REMARKS

Claim Rejections -35 USC §112

FIG. 1

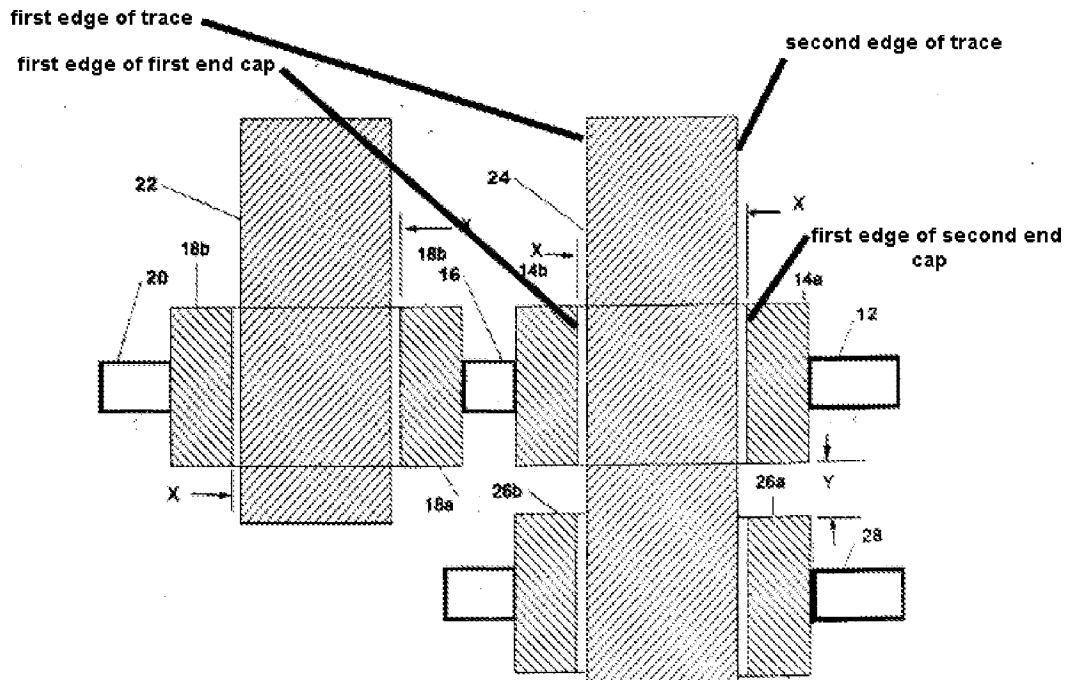
"Claims 63, 67, 72, 77, 81, and- 86 are rejected under 35 U.S.C. 112, second paragraph, as being indefinite for failing to particularly point out and distinctly claim the subject matter which applicant regards as the invention.

Regarding claim 63, lies (sic) 2-4 is unclear. What does applicant mean of "second edge of the trace and first edge of the second cap are both substantially equal to X"? Does applicant mean either the dimension or size of the second edge of the trace and -the first edge of the second cap are both substantially equal to X (0.1 in).

Rejected claims 67, 72, 77, and 88 are similar to claim 63.

Please clarify."

The issue raised by the Examiner seeks the meaning of a claim phrase. It is submitted that the language quoted is already clear when considered in the context in which it appears (the rest of the sentence/claim) particularly by referring to Figure 1 of the drawing.

The marked up copy of Fig. 1 of the drawing above is provided to emphasize that which is shown in the drawing including the explicitly labeled dimension. It will be understood that "X" is used to refer the dimension of the space intermediate both a first set of two edges as well as the dimension of the space intermediate a second set of two edges.

As used in claim 63 the dimension is an unspecified quantity, however, the claims make clear that both of the respective dimensions are substantially equal to X. Thus, the first and second dimensions are inherently substantially equal to each other. The use of the standard algebraic representation in claim 63 facilitates subsequent more specific
